UNITED STATES PATENT AND TRADEMARK OFFICE

Office Action Summary

10/598,969

DETAILED ACTION

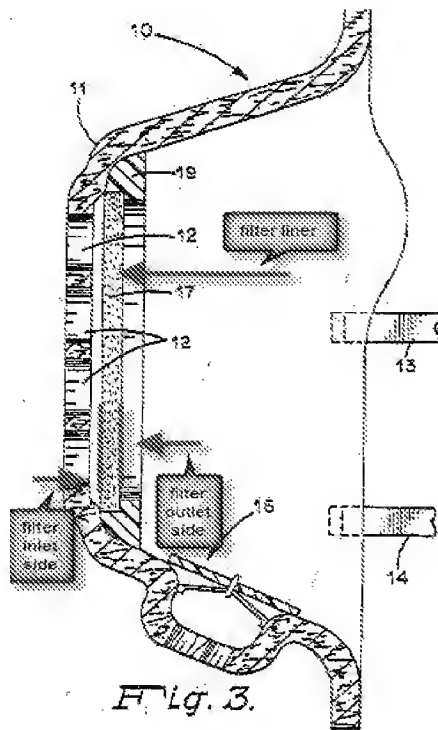
Regarding claim 1, figure 4 of Richardson discloses a respirator that covers a face of the wearer (column 3 lines 48-51) and incorporating a visor (50 - ocular mask). Figure 4 of Richardson shows a primary filter (7 - filter canister). Examiner regards Richardson discloses a primary volume (the volume excluding the secondary volume) where air can be drawn from the exterior (column 7 lines 25-26) via the primary filter (7). Examiner regards there is a secondary volume positioned to enclose the nose and mouth of the user (2 - oronasal mask) (see figure 4 below).

Richardson has a conduit connecting the visor (50) and the oronasal mask (2) but lacks a secondary filter to provide filter gas passing from the main volume to the secondary volume (see figure 4 below). However, figure 3 of Tayebi teaches a filter (17 - filter liner) can be provided to an oronasal mask (column 7 lines 31-35 and Abstract lines 1-3). Figure 3 of Tayebi shows that the filter liner (17) is provided prior to the air entering the oronasal mask to filter breathed air (Abstract lines 11-14). Therefore, it would have been obvious to one of ordinary skill in the art at the time the invention was made to provide Richardson's conduit with a filter liner as taught by Tayebi, since such a modification would provide purified air before the user inhales the air.

Regarding claim 3, figure 4 of Richardson discloses a primary inlet port (5 - air inlet) allowing air to be drawn into the first volume from the primary air filter (7), the primary inlet port (5) positioned on the outer mask (3).

Regarding claim 12, figure 4 of Richardson discloses an exhale valve (30 - relief valve) allowing air to travel from the secondary volume to the exterior of the outer mask (3).

Regarding claim 13, figure 4 of Richardson shows the oronasal mask (2) arranged to form a seal against a wearer's face such that the secondary volume forms a separate self contained volume (6) within the first volume when sealed against the wearer's face.

Regarding claim 14, figure 4 of Richardson shows a visor (50 – ocular mask) positioned within the first volume such that air traveling around the secondary volume passes proximate the visor (50).

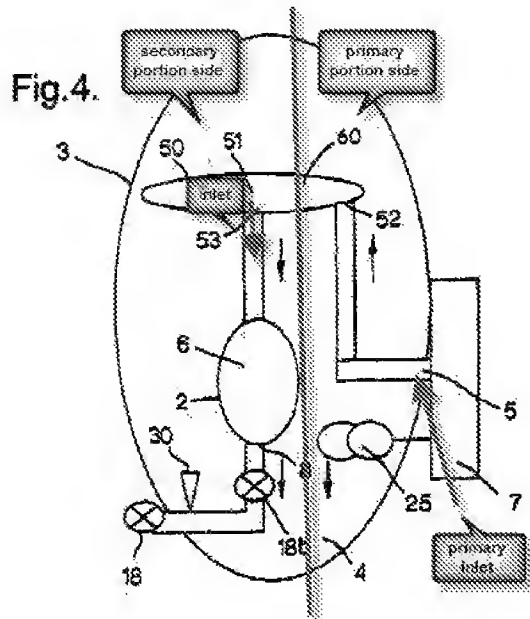
Regarding claim 2, the modified Richardson has the secondary filter (17 of Tayebi) filtering air traveling around a portion of the second volume, the secondary filter having a filter inlet for receiving air and a filter outlet for outputting air (see figure 3 of Tayebi below).
